File No: PRE-2003-097 Staff Planner: Pat Cecil
(To be filled in by City Staff)

**REVIEW COMMENTS ON MERIDIAN COMMERCIAL CONCEPTUAL PLAN -
ORCHARD MESA SANITATION DISTRICT (FILE #PRE-2003-097), 6/19/03.**

PRE-APPLICATION SITE PLAN

BEST BUY HOMES
MERIDIAN PARK
 PRE APPLICATION
 UTILITY COMPOSITE PLAN

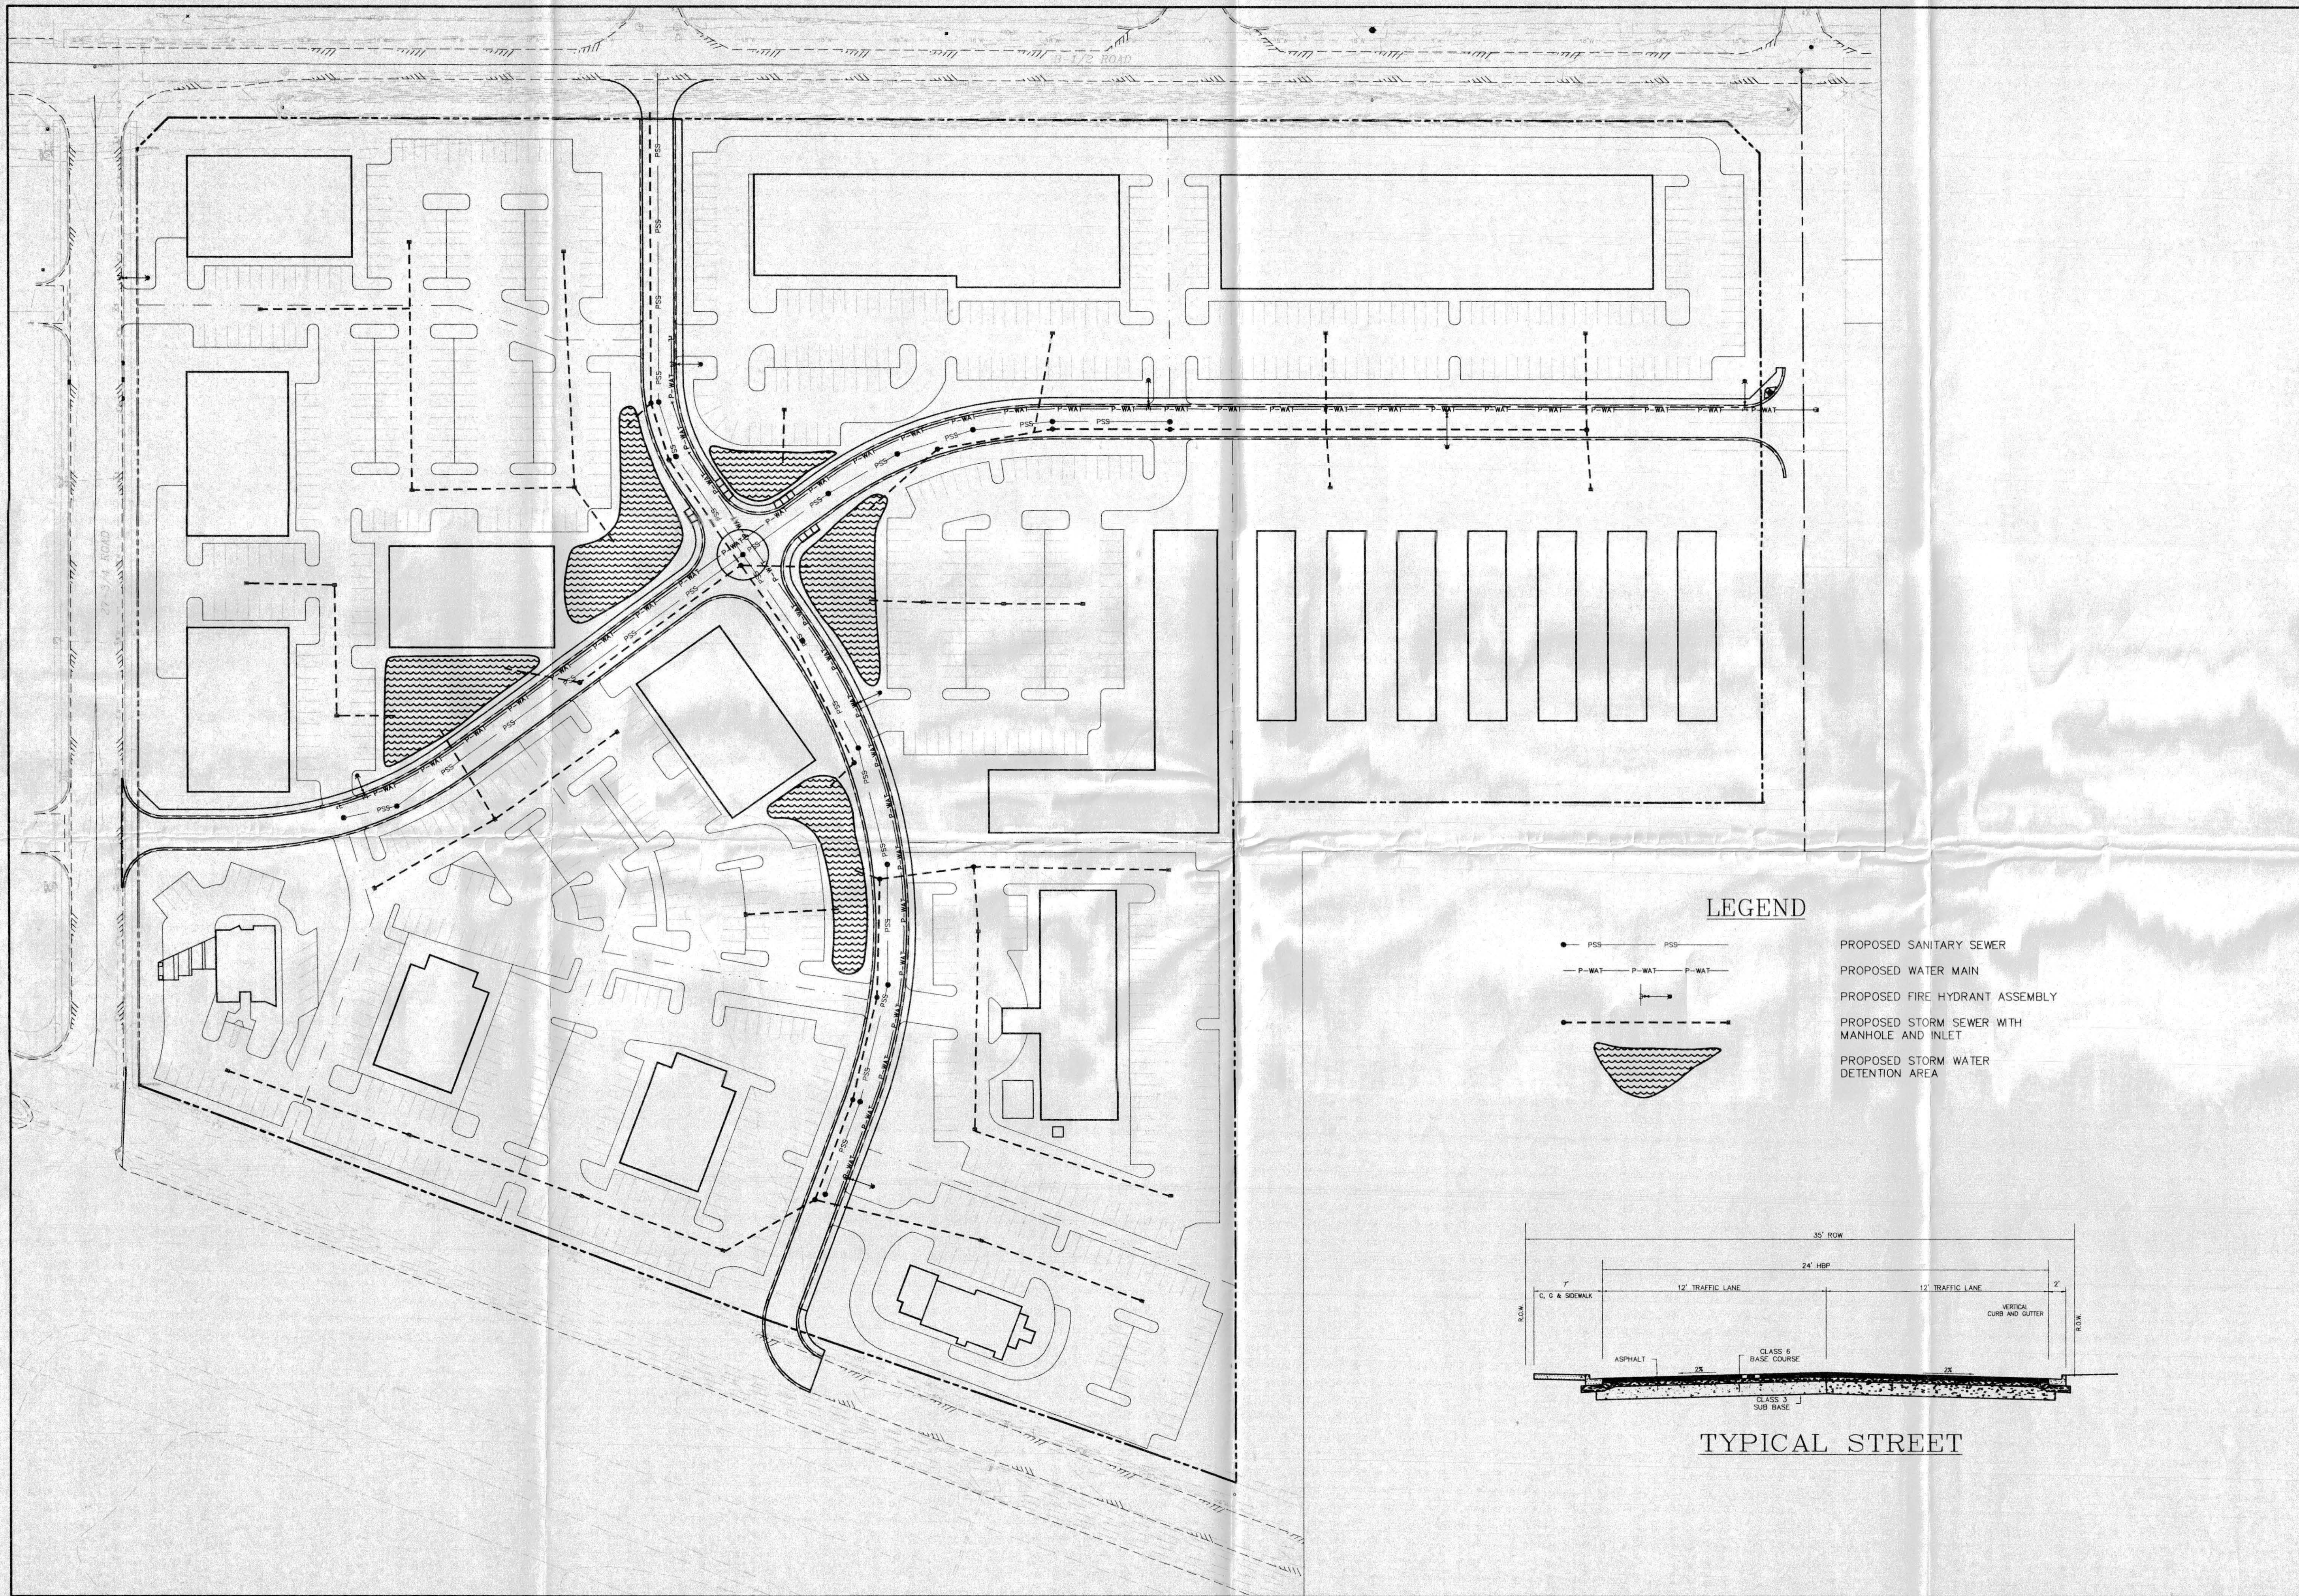
1. In order for the District to provide sewer service to the development it will be necessary to petition for inclusion into the District.
2. The sewer main along the street that would service future building sites on Lots 1, 2, and 3 should be extended further to the east toward 28 Road, so that future sewer service lines can be oriented perpendicular to the sewer main.

4. There is some question on how sewer service is to provided to the northerly most building pad for Lot 11. The District does not have a sewer main in 27³/₄ Road.

8. Is the internal intersection intended to be a roundabout or just a decorative intersection?
9. The landscaping shown on the Sketch Plan may interfere with sight triangles at the street intersections.

11. As stated in the General Meeting notes, this site has been identified as a possible location for a regional stormwater detention facility. This issue must be discussed with the City Utility Engineer.
12. Assuming that a regional stormwater detention facility will NOT be built at this site, it is recommended that the developers construct one basin to serve the entire project, rather than building individual basins for each lot.
13. The applicant must provide easements for the ditch along B ½ Road, similar to what was done for adjacent developments.
14. The Colorado Department of Public Health & Environment (CDPH&E), Water Quality Control Division, requires that a General Stormwater Discharge Permit be obtained for any construction site that will disturb 1 acre or more.

8. Is the internal intersection intended to be a roundabout or just a decorative intersection?
9. The landscaping shown on the Sketch Plan may interfere with sight triangles at the street intersections.
10. The site circulation for Lot 10 should be examined closely. If this is intended to be a drive-up bank, there may not be adequate stacking or room for circulation.

11. As stated in the General Meeting notes, this site has been identified as a possible location for a regional stormwater detention facility. This issue must be discussed with the City Utility Engineer.
12. Assuming that a regional stormwater detention facility will NOT be built at this site, it is recommended that the developers construct one basin to serve the entire project, rather than building individual basins for each lot.
13. The applicant must provide easements for the ditch along B ½ Road, similar to what was done for adjacent developments.
14. The Colorado Department of Public Health & Environment (CDPH&E), Water Quality Control Division, requires that a General Stormwater Discharge Permit be obtained for any construction site that will disturb 1 acre or more.

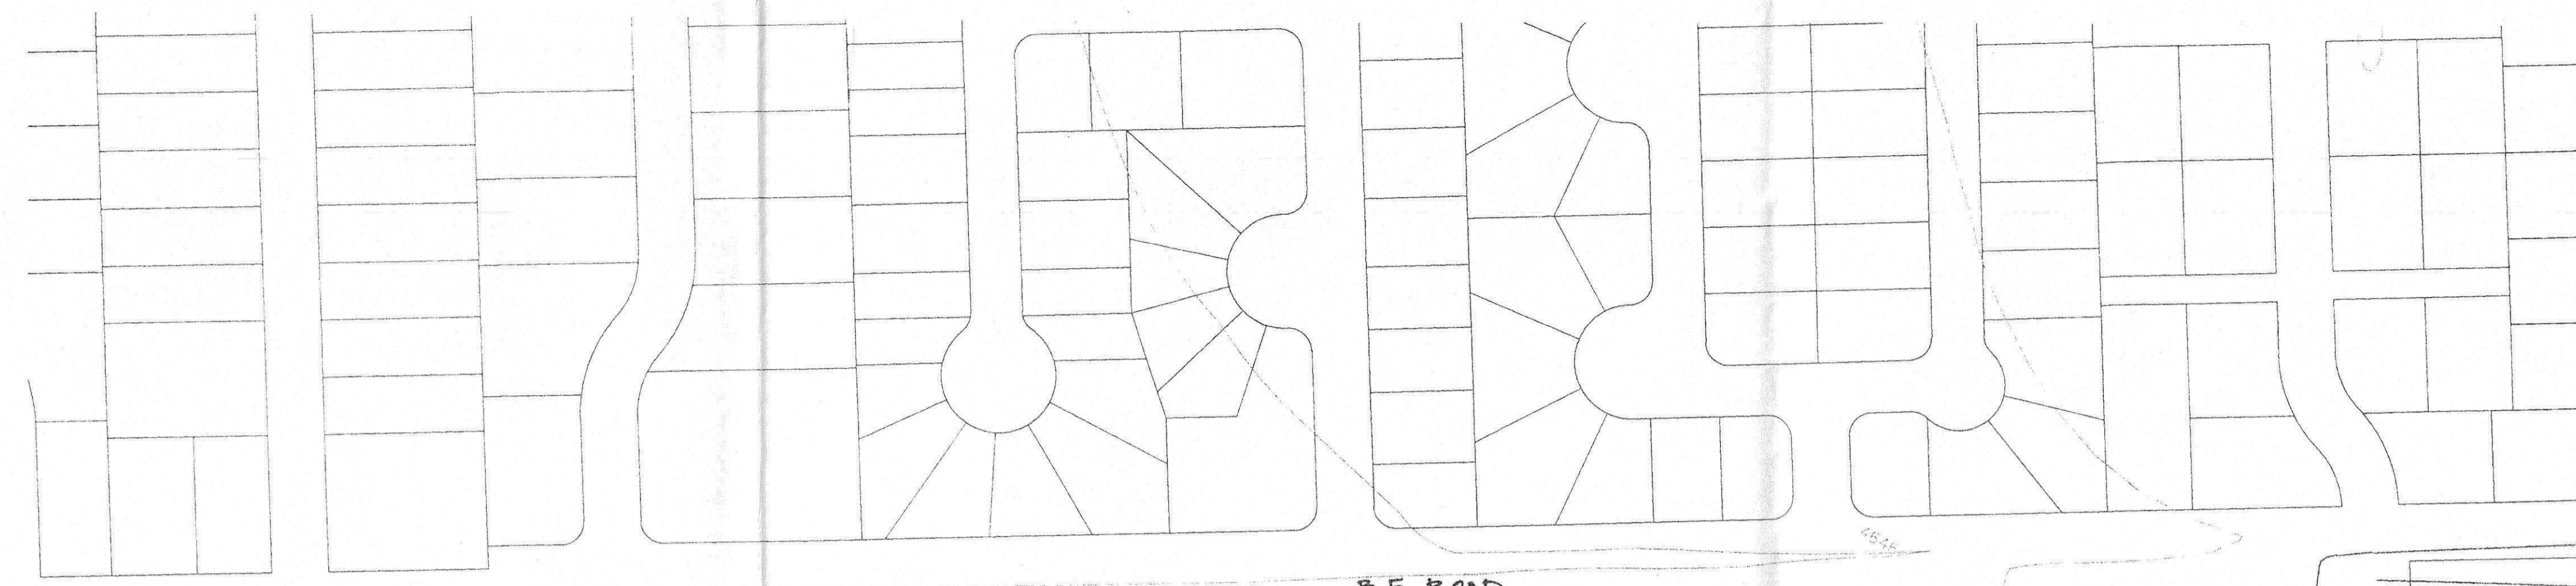
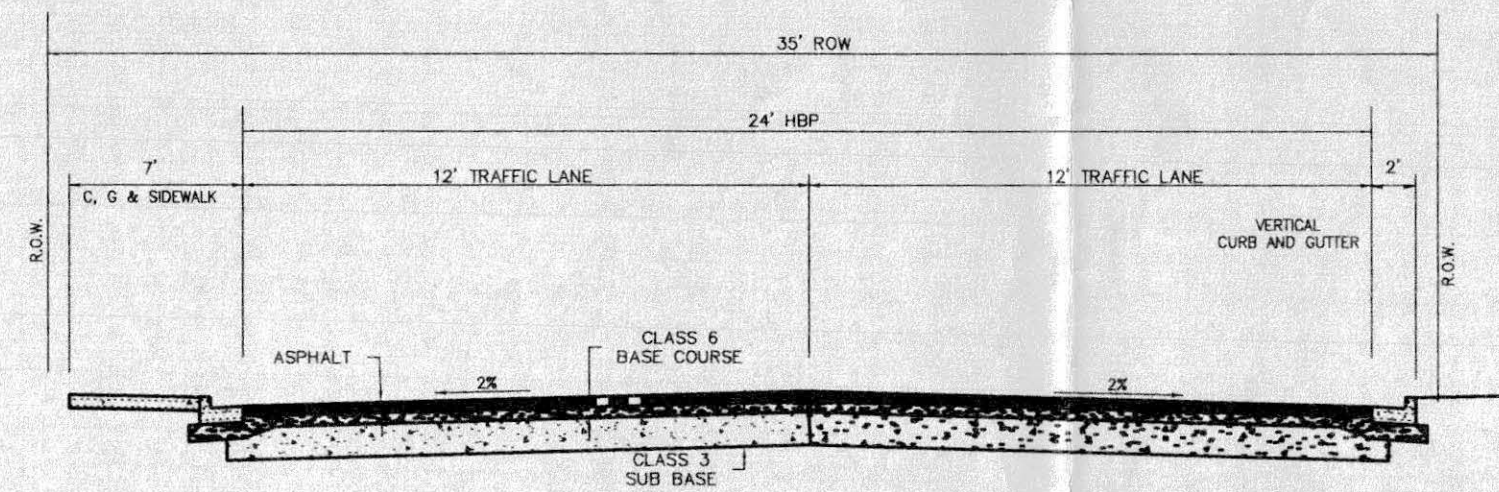
This letter is to request an exception to the TEDS manual in regard to typical street sections for the proposed Meridian Park development located at the intersection of B 1/2 Road and 27 3/4 Road. The street sections per TEDS would consist of a Minor Collector (Residential Collector) for the east to west road and Urban Residential for the north to south road. The proposed section for all internal streets includes 24 feet of asphalt, curb and gutter on both sides and sidewalk on one side. A detail of the proposed section is on the attached exhibit. Auxiliary turn bays will be provided where necessary in accordance with the Traffic Impact Study.

There appears to be a growing need for a typical section to address streets where parking is either not allowed or not likely to occur and will still adequately convey traffic without incorporating excessive traffic calming features. The section proposed for this development seems to achieve this and a typical (24' with curb, gutter and sidewalk) should be considered as an addition to the TEDS manual. Your time and consideration in this matter are greatly appreciated. If you have any questions or concerns regarding this project, please do not hesitate to contact this office at 243-6067.

This plan gives very little consideration to pedestrian and bicycle traffic within and through the development. Only the barest accommodation is provided for the properties to the east along the Frontage Road. As Jody points out, the project claims trip generation credit for saved trips within the development, but fails to recognize those trips with adequate facilities in this plan. Both of these streets appear to be attractive options for non-motorized trips between B1/2 Road and the highway.

I could agree that there is little need for Collector Streets through this limited area. However, both corridors seem appropriate for standard Commercial Street sections. These will provide bike lanes and sidewalks like any other commercial development.

No other options were presented. I have suggested another possibility above. A third option might be to remove the bike lanes from the pavement and combine them with the pedestrian traffic on a separated 10-foot pathway along each side. A fourth option might be to only have the north-south connection to the Frontage Road be a public Commercial Street. The east-west street could be a narrower private drive as long as sufficient pedestrian and bicycle circulation is provided within the overall plan.

I recommend denial of the requested Design Exceptions to Section 6.1.1 to allow the proposed elimination of the sidewalk along one side and reduction of the pavement width for these streets. The committee might consider any or all of the other options mentioned above, or other(s) the committee might think of, as a modified approval.

- * A PRESSURE REGULATING VAULT WILL BE REQUIRED TO CONNECT WATER LINES IN HIGHWAY 50 ROW TO PROPOSED WATER LINES IN SUBJECT PROPERTY.
 - * CHECK SPACING ON FIRE HYDRANTS IN PROPOSED SUBDIVISION.
 - * UTE RECOMMENDS THAT 4" OR 6" STUBS BE INSTALLED FOR EACH LOT FOR WATER SERVICE, THIS WOULD LIKELY COVER BOTH DOMESTIC AND FIRE REQUIREMENTS AS NEEDED.
 - * ALL FEES AND POLICIES IN EFFECT AT TIME OF APPLICATION WILL APPLY
- If you have any questions concerning any of this, please feel free to contact Ute Water.

Please find attached the committee's decision on the above request. The Review Committee believes there will be at least as much pedestrian and bicycle traffic through this area as any other commercial development due to its proximity to the fairgrounds, Highway 50 and the City Market shopping area. Although the Committee denied this request, the notes at the bottom are intended to give you some direction regarding what modifications to this roadway system would be considered for exception by them. In any exception request it will be important to consider and accommodate all of the necessary uses of the road system. Generally, any requested adjustment to the street cross-sections will be evaluated on its ability to meet all of the traffic needs of the area. Sufficient analysis by a qualified professional will be an expected piece of any request of this type.
